Intersection ID: 7944	Main Street: DAVID_AV	Cross Street: RUNNING_DEER_RD	Location:	N/A
ADA ID: 96DD0E7AD368	Ramp Type: Perp	Initial Pass/Fail: Fail	Overall Compliance: No	Severity Score: 8.75

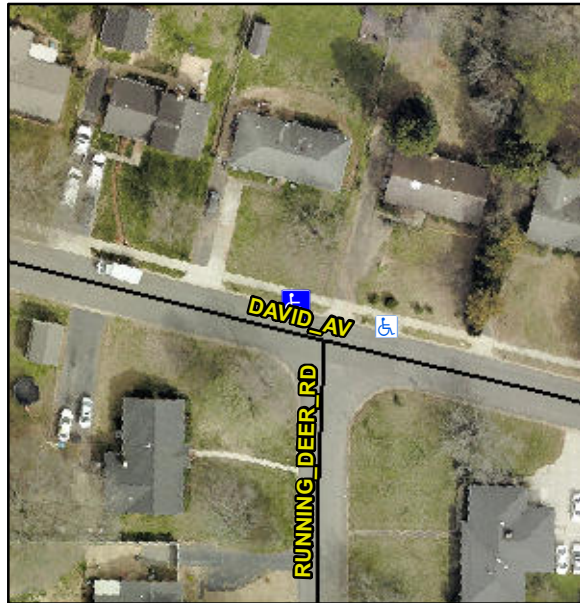
Not Found, R304.5.1

Compliance	Description	Data	Compliance	Description	Data
N/A	Ramp Length (in)	47.0	Yes	Ramp Slope (%)	7.2
No	Ramp Width (in)	47.5	Yes	Ramp XSlope (%)	1.9
N/A	Flare Type LT	N/A	N/A	Flare Type RT	N/A
N/A	Flare Slope LT (%)	N/A	N/A	Flare Slope RT (%)	N/A
N/A	Flare Traversable LT?	N/A	N/A	Flare Traversable RT?	N/A
N/A	Landing Length (in)	N/A	N/A	DWS Provided?	N/A
N/A	Landing Width (in)	N/A	N/A	DWS Contrast?	N/A
N/A	Landing Slope (%)	N/A	N/A	DWS Length (in)	N/A
N/A	Landing X Slope (%)	N/A	N/A	DWS Full Width?	N/A
N/A	Landing Curb? (Y/N)	N/A	N/A	DWS Offset (in)	N/A
N/A	Shared Landing?	N/A			
N/A	Gutter Ponding?	N/A	N/A	Gutter Slope (%)	N/A
N/A	Gutter Lip Ht (in)	N/A	N/A	Gutter X Slope (%)	N/A
N/A	Painted X Walk1?	No	N/A	Painted X Walk2?	N/A
	X Walk 1 Direction	To S		X Walk 2 Direction	N/A
N/A	X Walk 1 Width (in)	N/A	N/A	X Walk 2 Width (in)	N/A
	X Walk 1 Slope (%)	5.6		X Walk 2 Slope (%)	N/A
	X Walk 1 X Slope (%)	2.7		X Walk 2 X Slope (%)	N/A

Remove & Replace Entire Ramp.
